The Victorian division of the Urban Development Institute of Australia (UDIA) welcomes the opportunity to respond to the *Fishermans Bend Framework* draft for consultation. UDIA appreciates that the Fishermans Bend Taskforce has been working to deliver to the community a viable framework that will enable this unique urban renewal site to realise its highest potential.

UDIA Victoria Submission – Fishermans Bend Framework Discussion Paper Response to the Draft for Consultation

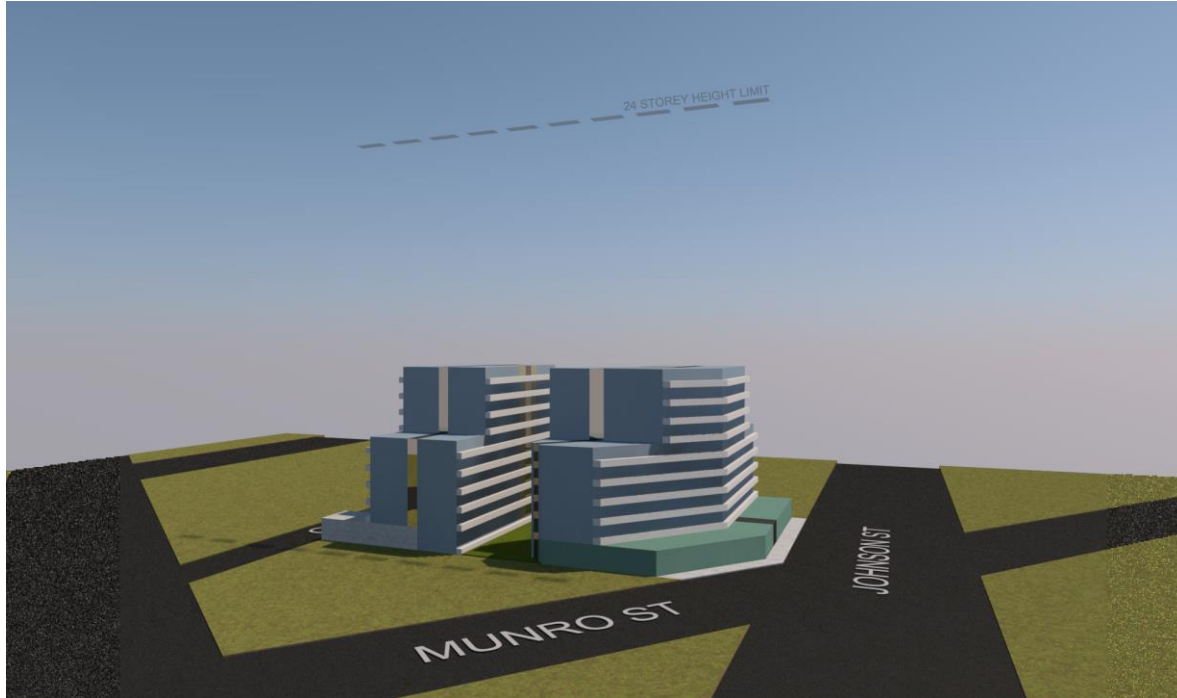
The maximum height in this location is 24 Stories. The FAR of 3.3 will achieve a building height of 10 stories. See image on following page.

The developer would most likely build affordable apartments in order to take advantage of the FAU and the allowable height being 24 stories. See the second image on following page.

Assuming an apartment costs roughly \$320k in raw construction cost, and the developer is allowed to build eight additional apartments, the result is an effective land component of \$40k per apartment. This is viable if the developer is looking to buy the site after these controls are in place.

On this particular large site, interpretation of the controls works to produce a good outcome if the intention was to use the FAU to install affordable housing. The built form below the green floors is what can be produced if the FAU is not utilised. It is 9 storeys. If two levels of affordable apartments (shown in green) are added, 16 extra levels of apartments are gained. This easily allows the proposal to achieve 24 levels.
